1992 - 1993 Corvette: Service Bulletin: Noisy/Fraying Accessory Drive Belt

Subject: NOISY/FRAYING ACCESSORY DRIVE BELT (INST. SINGLE-SIDED BELT)

Model and Year: 1992-93 CORVETTE WITH 5.7L (LT1) ENGINE

Bulletin Number: 93-273-6A

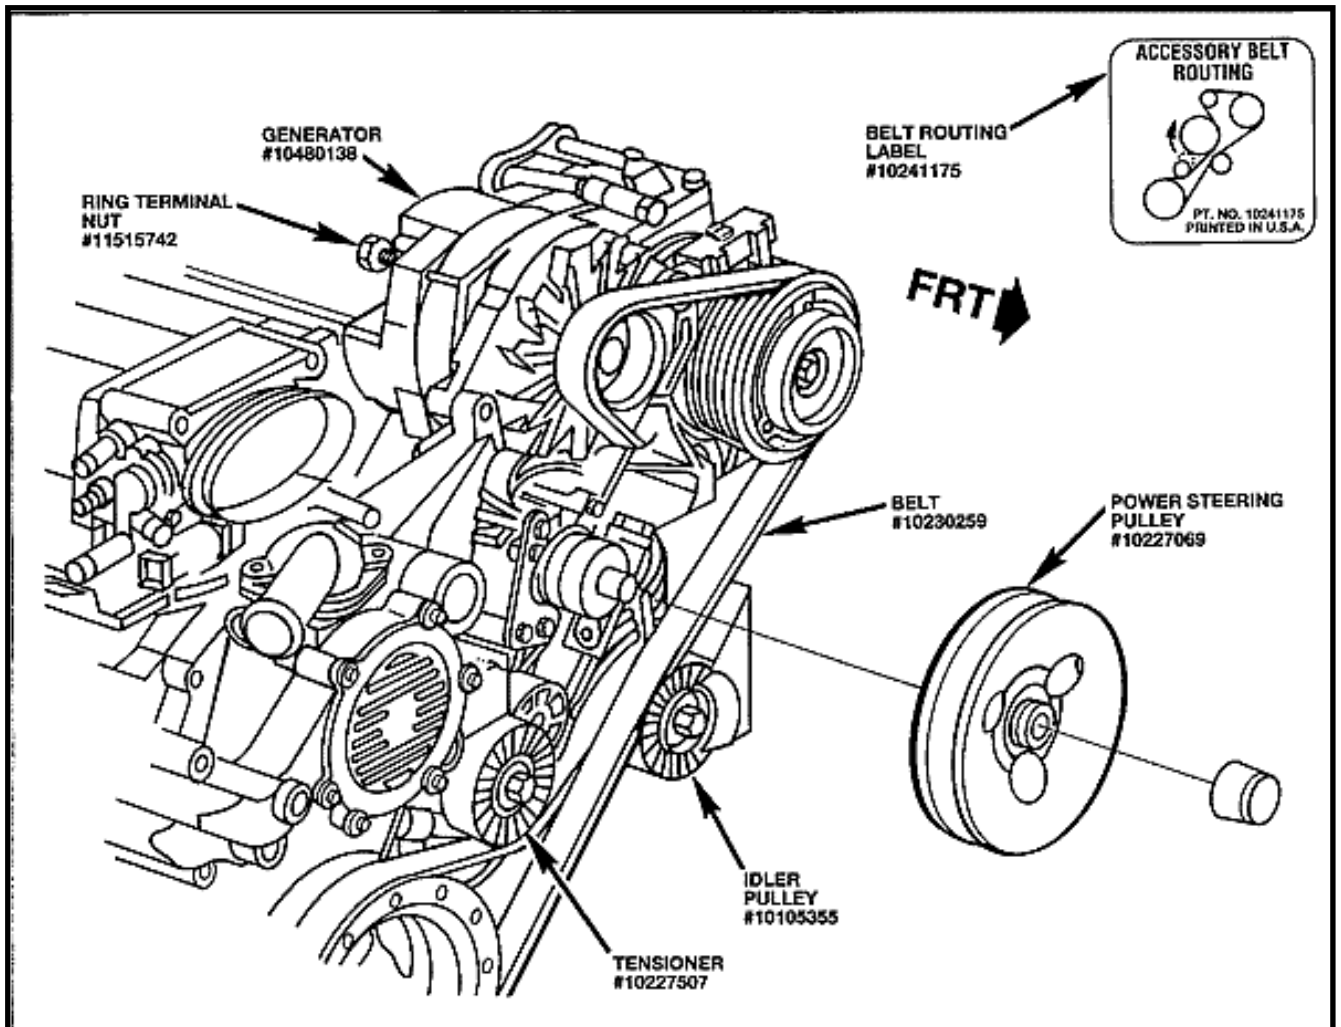
Some owners of 1992 and early 1993 model year Corvettes with 5.7L (LT1, VIN P) engines using the double-sided accessory drive belt may experience a noisy or fraying belt condition.

Inherent stresses and/or processing of the double-sided belt.

To correct this condition a change was made from the double-sided belt system to a new single-sided belt system. Starting the week of March 22,1993, VIN breakpoint #1G1YY23P4P5113150 Corvettes with LT1 engines were built with the new single-sided belt. To repair older units with the double-sided belt to a single-sided belt, the following parts must be installed:

- 10227507 Tensioner
- 10227069 P/S Pulley
- 10105355 Idler Pulley
- 10463533 Generator
- 11502811 Generator Ring Terminal Nut #M8

NOTE: When replacing the new generator, the ring terminal on the wire harness will have to be opened up the 8.5mm to accommodate the larger stud on the back of the new generator.
